# CITY OF ALBUQUERQUE

**RE: Lot 36 Block 5 Unit 5 SAD 227  
8008 Monte Carlo Dr. NW  
Grading and Drainage Plan  
Engineers Stamp Date 6/16/2020 (E10D080)  
Pad Certification Date 7/27/2020**

## DRAINAGE AND TRANSPORTATION INFORMATION SHEET (REV 6/2018)

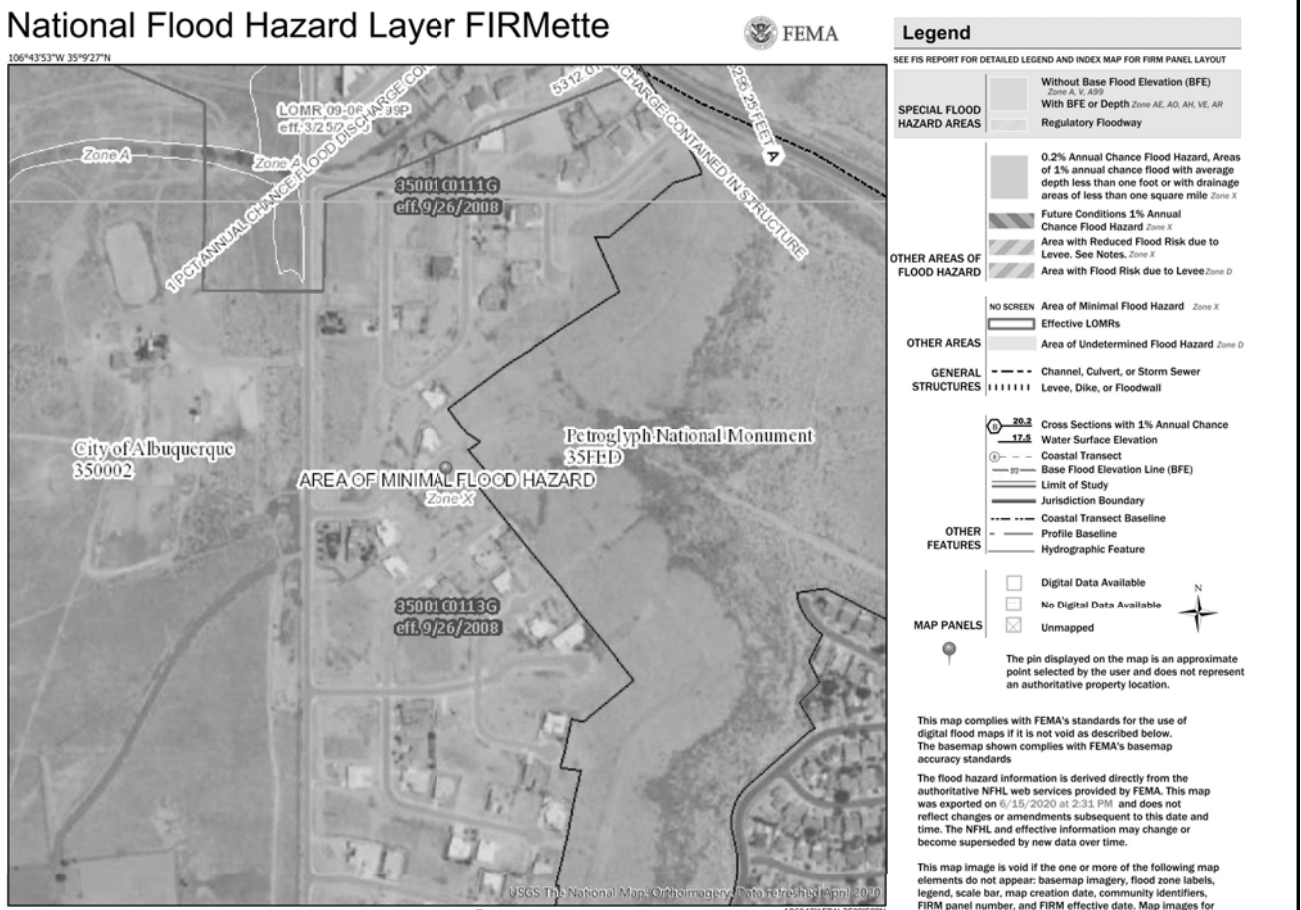
Based upon the information provided in your submittal received 4/8/2020, this plan is approved for Building Permit.

Reiterate to the Owner/Contractor that a separate permit for a garden/retaining wall must be obtained, with the approved G&D plan.

Prior to Certificate of Occupancy release, Engineer Certification per the DPM checklist of this plan will be required.
